Response to Highway Comments – Lilley Hoo Farm, Lilley Hoo Lane

This Highways Response Letter has been prepared following receipt of Hertfordshire County Council's (HCC's) highways consultation responses regarding the proposed change of use at Lilley Hoo Farm into light industrial (E(g)iii) or warehousing (B8) land uses, as part of application references NH/26579/2025 and NH/26578/2025 respectively.

LILLEY HOO FARM,
NORTH HERTFORDSHIRE

ADDITIONAL PASSING POINT
AND SWEPT PATH ANALYSIS

PROJECT No: 5973	DRAWING No: SK02
---------------------	---------------------

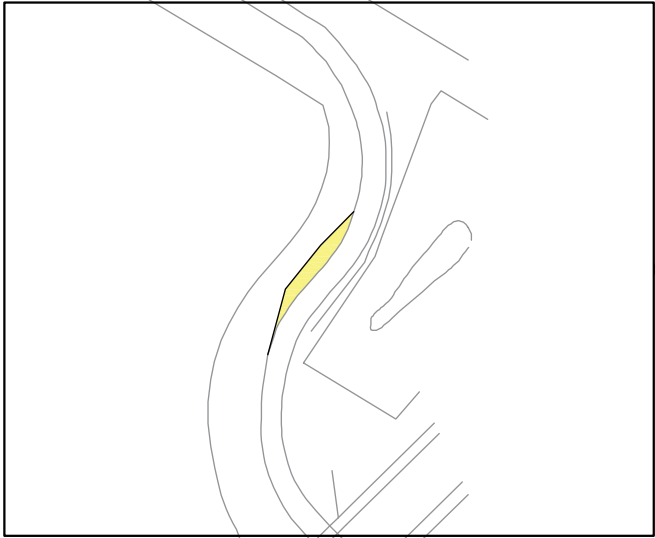
"The applicant has submitted drawing Ref-(SK01), which illustrates two passing bays designed for HGVs. The Highway Authority acknowledges the effort made to incorporate these bays, facilitating vehicle movement along the narrow carriageway.

However, visibility becomes an issue especially north of the underpass. How will vehicles observe an oncoming vehicle which has gone through the 90-degree right turn, followed by a 90-degree left turn."

However, visibility becomes an issue especially north of the underpass. How will vehicles observe an oncoming vehicle which has gone through the 90-degree right turn, followed by a 90-degree left turn.

As a result of the comments received from HCC Highways, A third passing point is now proposed, in addition to the two passing points initially outlined within the Transport Technical Note dated July 2025. This third passing point will be located between the two bends referenced in the Highway Officer's comments to accommodate for a scenario in which a HGV meets an oncoming vehicle within this section of carriageway.

The third passing point is demonstrated in SK02 contained at **Appendix C** of this report. This has been demonstrated to accommodate a scenario in which a large articulated vehicle passes an incoming medium sized delivery vehicle.

It should be reiterated that the likelihood of two vehicles of any size meeting at this point is very low, and as such the likelihood of two OGV/HGVs passing simultaneously at this point is exceptionally low. As such, it is considered that the proposed third passing point should be appropriate in the context of the proposed development and expected trip generation.
